3. Wonder View Subdivision; KPB File 2023-139
Fixed Heights, LLC / AK Mental Health Trust Authority
Location: Wolf Street
Nikiski Area / Nikiski APC

ITEM #3 - PRELIMINARY PLAT Wonder View Subdivision

KPB File No.	2023-139
Plat Committee Meeting:	January 22, 2024
Applicant / Owner:	Alaska Mental Health Trust Authority / Anchorage, Alaska
Surveyor:	Buku Saliz / Fixed Height LLC
General Location:	Wolf Street in Nikiski, Nikiski APC

STAFF REPORT

WONDER VIEW SUBDIVISION

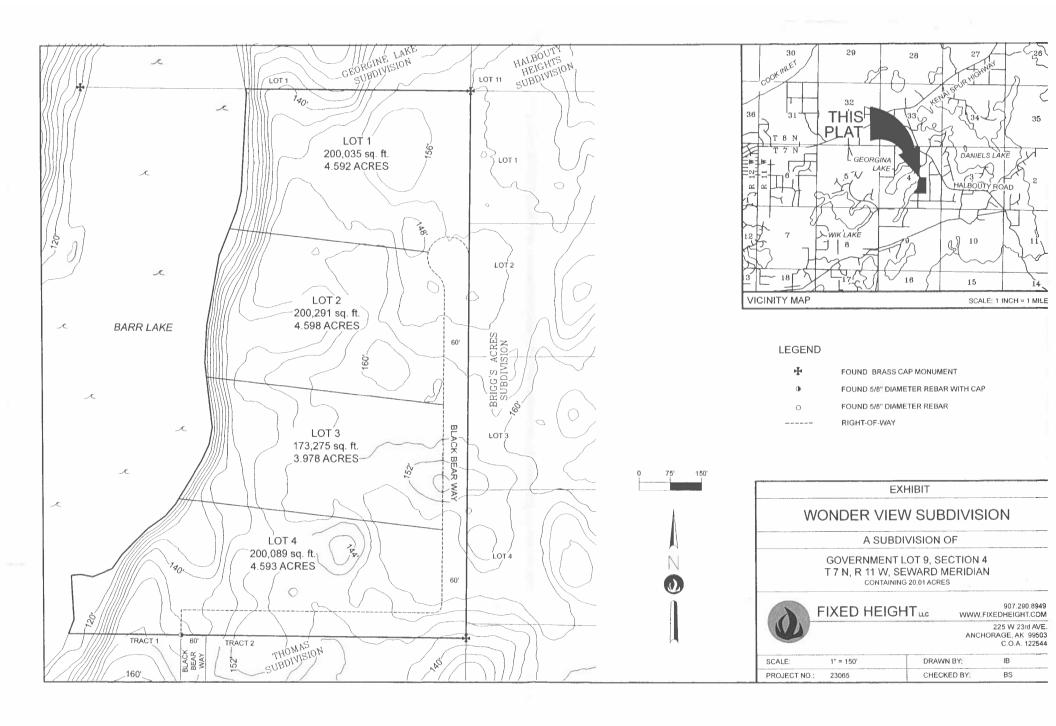
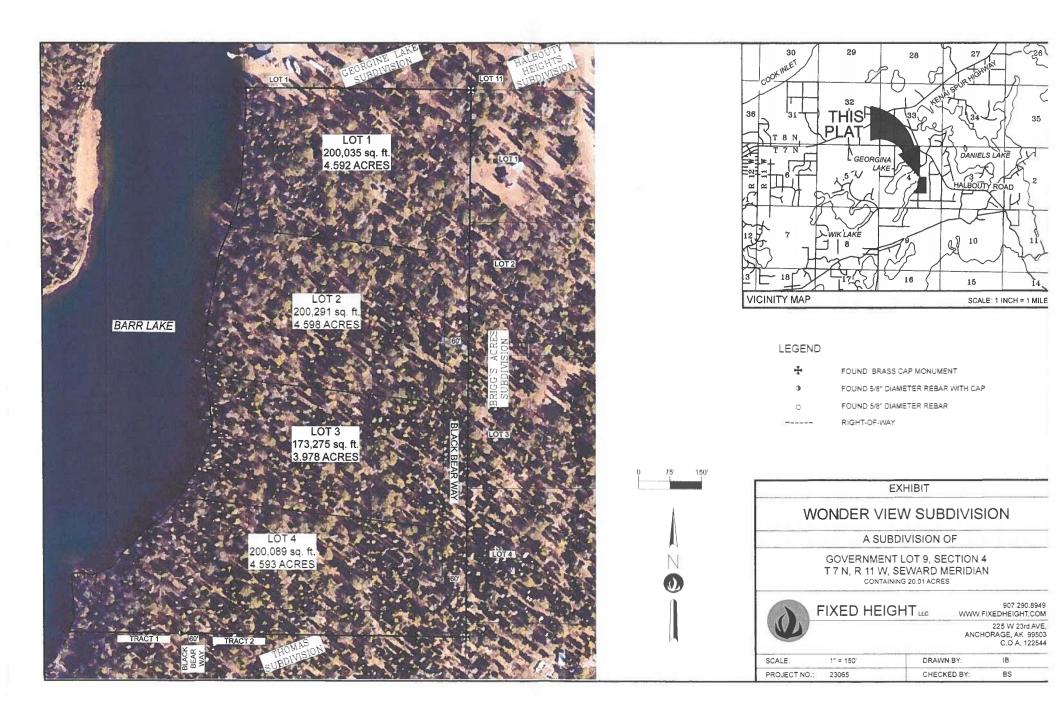
Per KPB 20.30.240 a 20 foot building setback needs to be identified on the subdivision. Please add a note to the plat and corresponding lines to the drawing.

Black Bear Way needs a new suffix to end in as it is ending in a cul-de-sac, per Addressing. **Staff recommends:** the surveyor contact Addressing for the correct suffix for street name.

<u>Utility Easements</u> There is a utility easement line identified in the legend. A note concerning the 10 foot utility easement along the right-of-way should be added to the plat and to the drawing.

HEA is requesting a 20 foot easement along the east line of Lot 1 coming from the northeast corner down to the cul-de-sac. This will be for a connection from the transformer to the 10' utility easement. **Staff recommends:** adding this easement.

Add Kenai Peninsula Borough, Alaska to the legal description.

Verify the address of the owner, assessing list a different address.

Add the number 2023-139 to the KPB file No.

Black Bear Way to the south is labeled incorrectly should be Wolf Street.

Add a north arrow to the vicinity map

Reduce the scale of the map for better readability

Correct the spelling of Georgine Lake

Extension of Black Bear Way needs new name already used, need to get Addressing.

All adjacent parcels need to have the subdivision filing added to them.

Parcels to the north and east need the block numbers added to them.

Give distances along east and south lines of road.

Make bearing sun in same direction on lines.

Label 10' utility easement on drawing or do a typical drawing detail.

- Roads must meet the design and construction standards established by the borough in order to be considered for certification and inclusion in the road maintenance program (KPB 14.06).
- Complete notes 5 & 6 appropriately

Add the date of January 22, 2024 to the Plat Approval

After getting with Addressing to get correct name of road, change name in Certificate of Acceptance Confirm address of owner in the Certificate of Ownership.

Set witness corner on the property lines near the lake.
